**From:** <Richard.Olsson@ski.se>  
**To:** OWFN\_DO.owf4\_po(RFD)  
**Date:** Thu, Apr 27, 2000 5:21 AM  
**Subject:** VB: Draft Final Technical Study SFP Risks at Decom NPPs

Issued by  
Mats Sjöberg/ Ferenc Müller

**Questions/Comments on the NRC "Draft final technical study of spent fuel accidents risk at decommissioning nuclear power plants", 7590-01-P.**

FIGURE 1: Envelope Ground Response Spectra for a (principal) horizontal GM direction, relating to exceedance frequencies  $10^{-5}$ ,  $10^{-6}$  and  $10^{-7}$  annual events per site and damping ratios 0.005, 0.02, 0.05, 0.07 and 0.10.

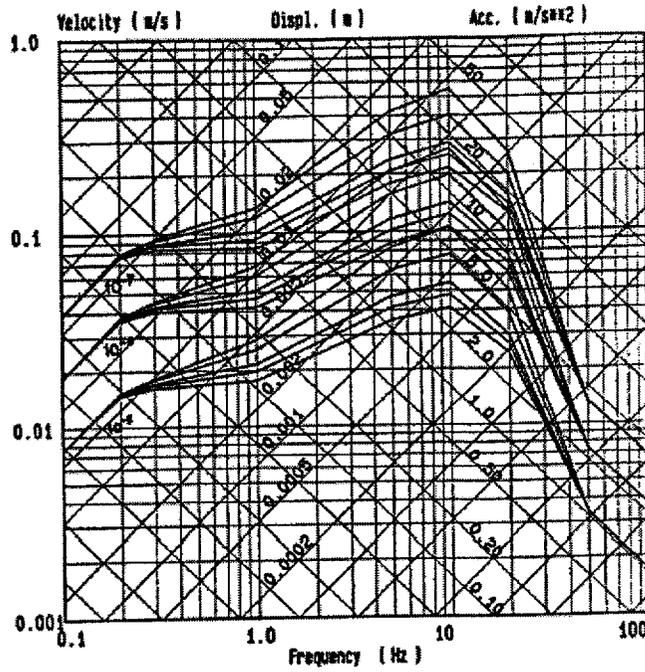
5. An US earthquake response spectra  $10^{-5}$ /year (0.5g) is considered as a  $10^{-7}$  in Sweden. Does this justify exemption from further consideration, due to low yearly frequency for Zr-fire? The SFP at the Swedish plant is calculated with an earthquake 0.1g, see response spectra Figure 1, and found to comply with the Swedish standard design standard (Boverkets Konstruktionsregler 94, BKR94.
